*Proof of evidence for planning appeal inquiry (S/3290/19/RM): David Cottee*

**INQUIRY INTO THE APPEAL BY CASTLEFIELD INTERNATIONAL LIMITED  
AGAINST REFUSAL OF RESERVED MATTERS APPLICATION BY  
SOUTH CAMBRIDGESHIRE DISTRICT COUNCIL AT  
LAND AT TEVERSHAM ROAD, FULBOURN**

**PROOF OF EVIDENCE OF David Cottee D.Arch RIBA**

**Planning Appeal Ref: APP/W0530/W/22/3291523**

Drawing number  
TRF-CBA-1-GF-M2-L-4001

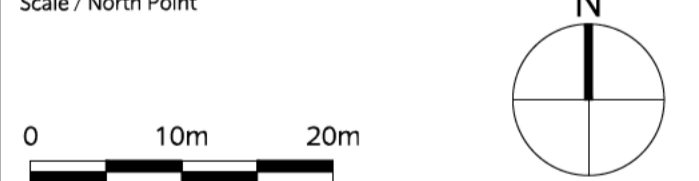
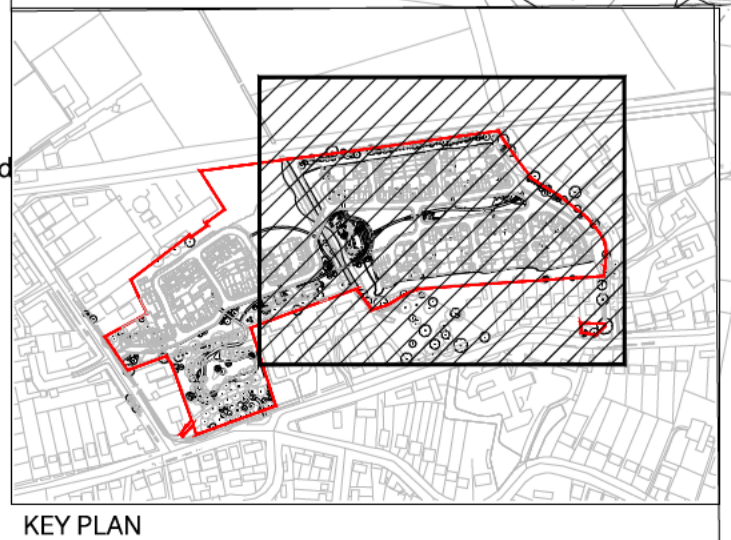
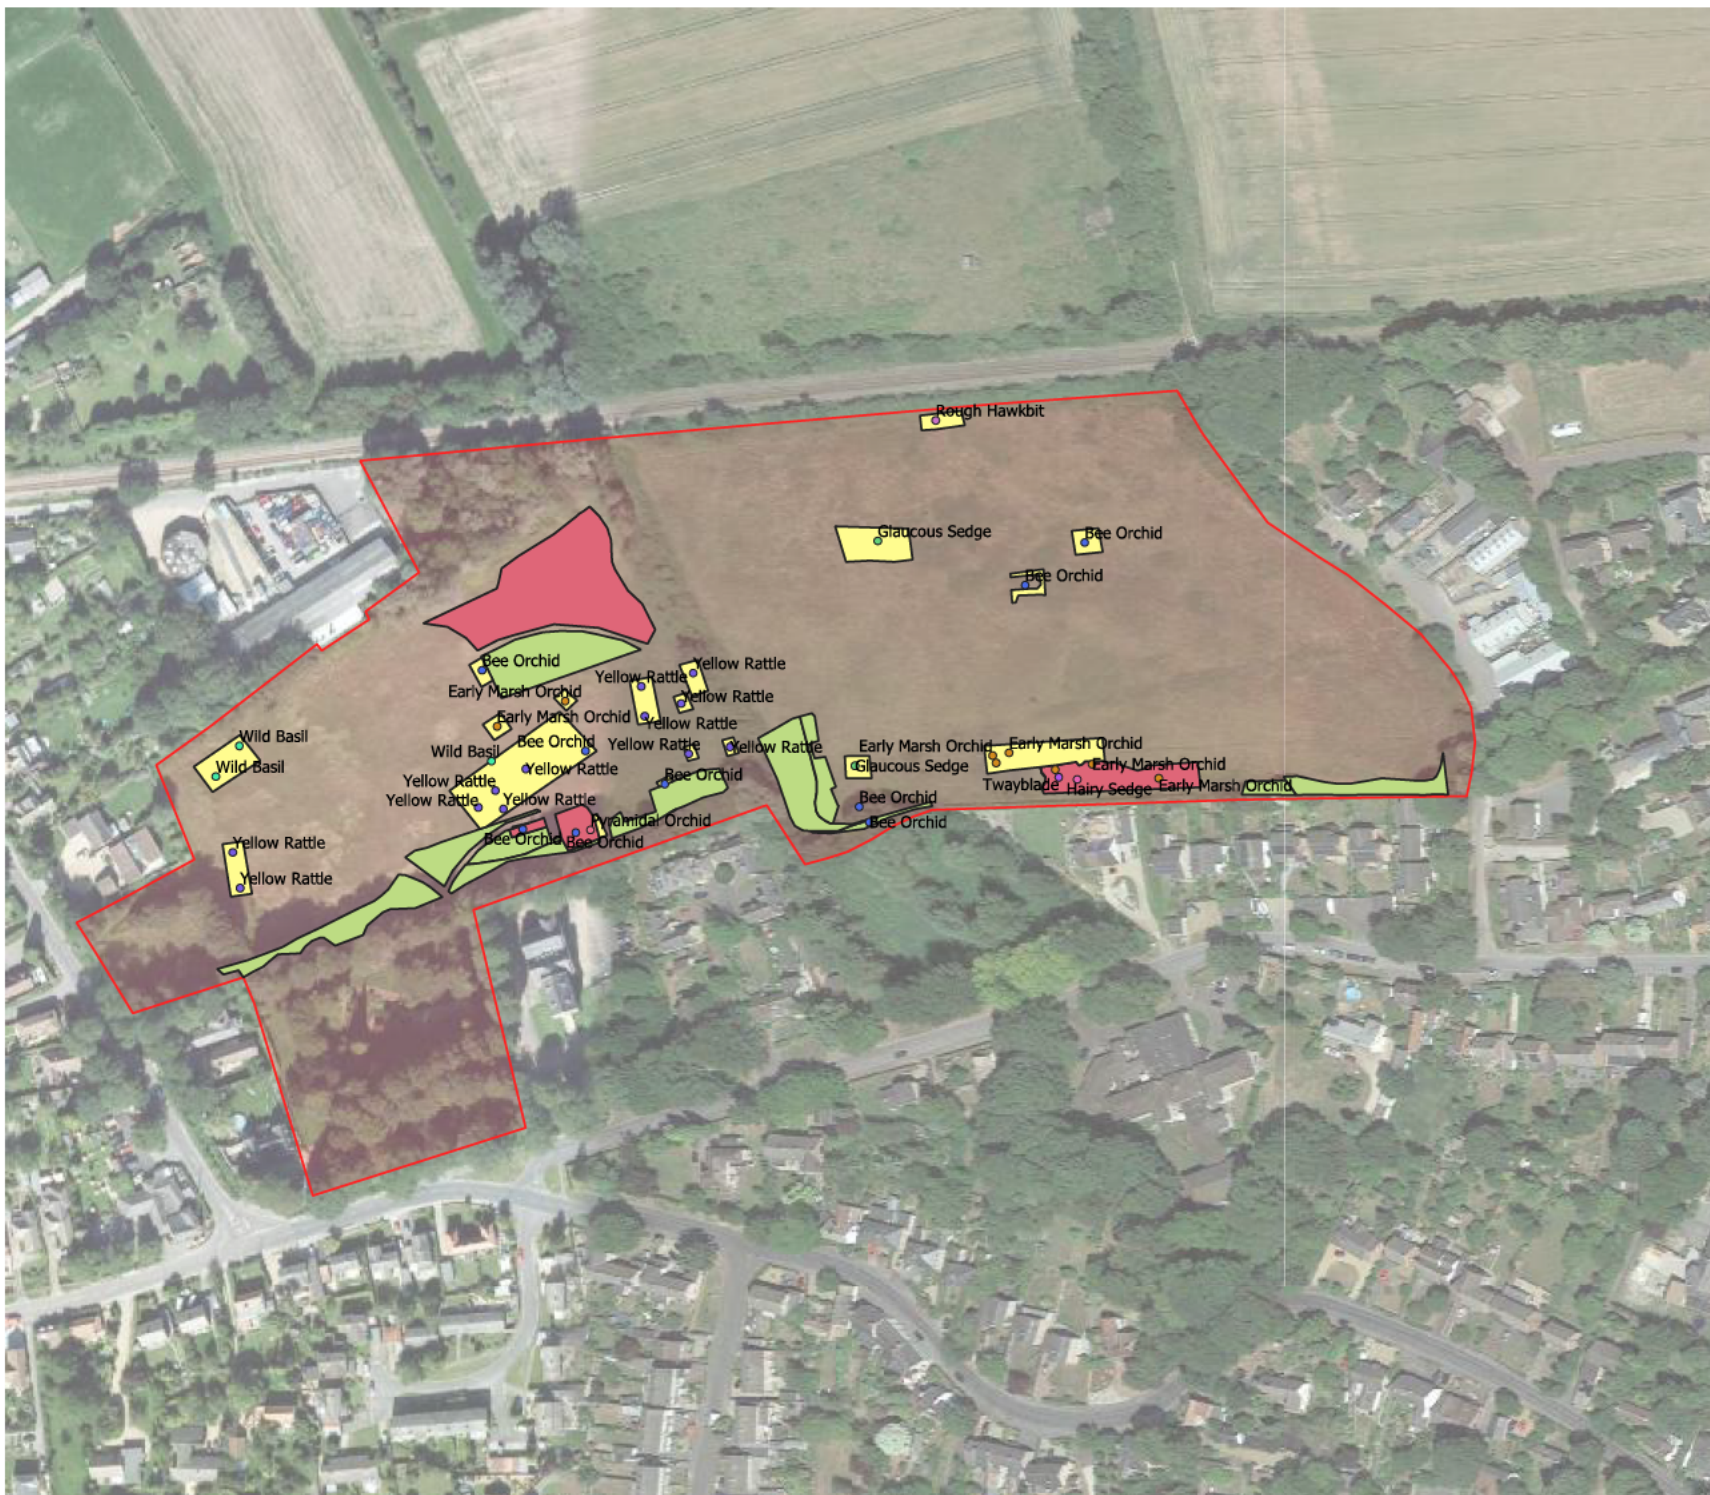
- 4.7 The design and layout of the proposed development fails to respond to these principles and policy requirements on many counts. Most streets are not tree-lined, and the development on the raised platforms does not respond to the Fulbourn Village Design Guide (FVDG) [CDE5] guidance of *“...any development should contribute to the richness of the rural-style greenery through retention and planting of new large trees and hedgerows”* (para.6, page10). The small, narrow front gardens and side verges with lawn grass, or small shrubs and groundcover plants, do not begin to address the guidance of the FVDG (Chris Blandford Ass. Planting Strategy TRF-CBA-1-GF-M2-L-4000 Rev.P3, and 4001 Rev.P3) [CDA3].
